| RE: Recall Campaign 2015080001 Replace Seal on Secondary Bulkhead MY2016 Model 212 (E-Class), MY2015 Model 218 (CLS) | DATE: August 26, 2015 |

Campaign No. 2015080001, August 2015

SUBJECT: **Models 212 (E-Class), 218 (CLS-Class), Model Year 2015
Replace Engine Compartment Seal and 4 Clips at Partition Wall**

Figure 1

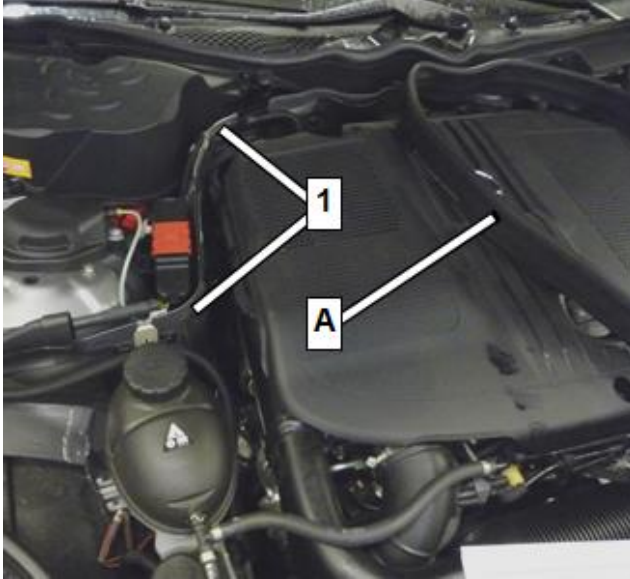
1.  Open hood and remove entire engine compartment seal (A, Figure 1) from partition wall (1).

Figure 2

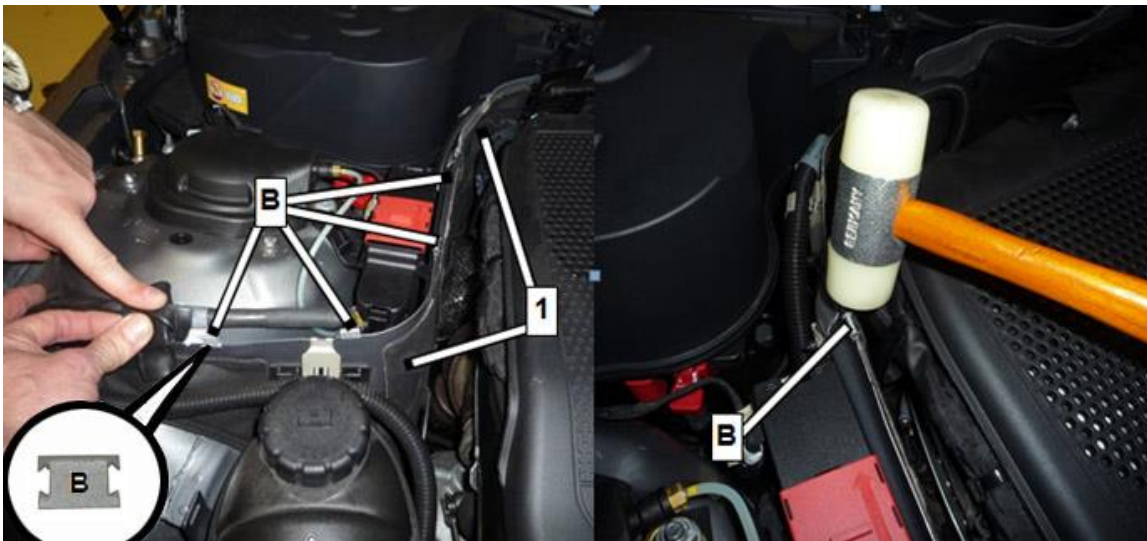
2.  Replace 4 retaining clips (B, Figure 2) at partition wall (1).

-  Hammer new retaining clips (B, Figure 2) onto upper edge of partition wall (1) using **plastic** mallet.

Figure 3

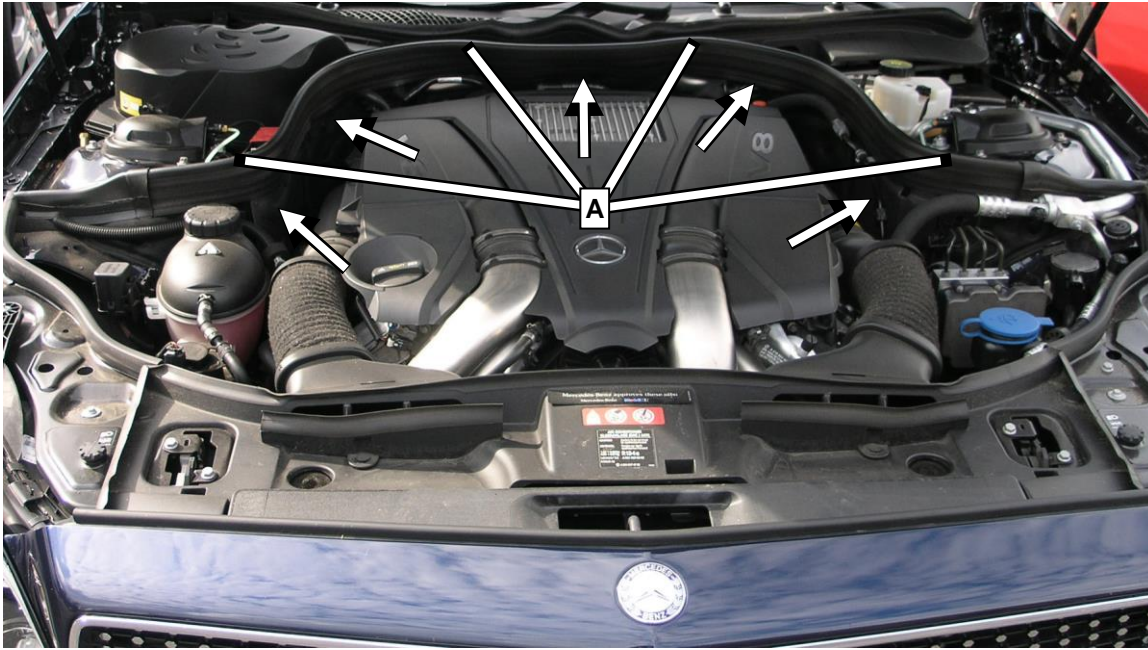
3.  Install **new** engine compartment seal (A, Figure 3) onto partition wall (arrows) and close hood.

-  New engine compartment seal (A) must be installed **firmly** on partition wall (arrows).
